PLANNING DIVISION STAFF REPORT

July 29, 2019

Project Address: 223 South Pinckney Street (District 4- Ald. Verveer)

Application Type: Demolition Permit, Planned Development Alteration, Conditional Use, and Certified Survey Map

**Above: West Wilson Street - Lower Levels of Hotel
March 22, 2017 Plans**

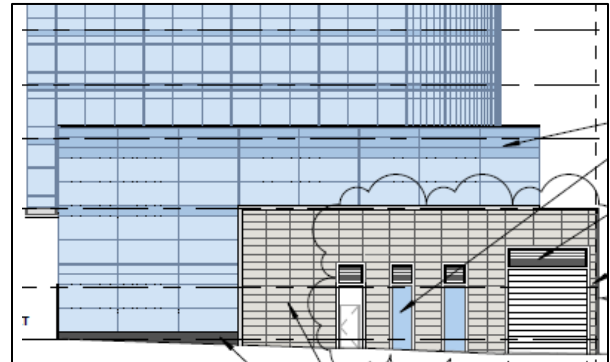
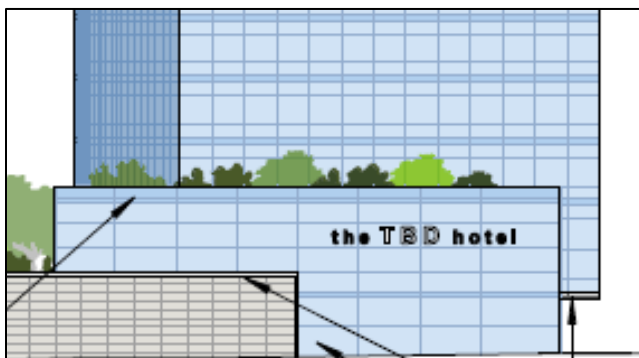
Corresponding façade changes are proposed to the East Wilson and Doty Street facades. Along Wilson Street, the previously approved underground parking entrance is now comprised of a door and spandrel-clad panels. Along Doty Street, additional windows and doors to an enclosed bike parking area are now proposed. No changes are proposed along South Pinckney Street.
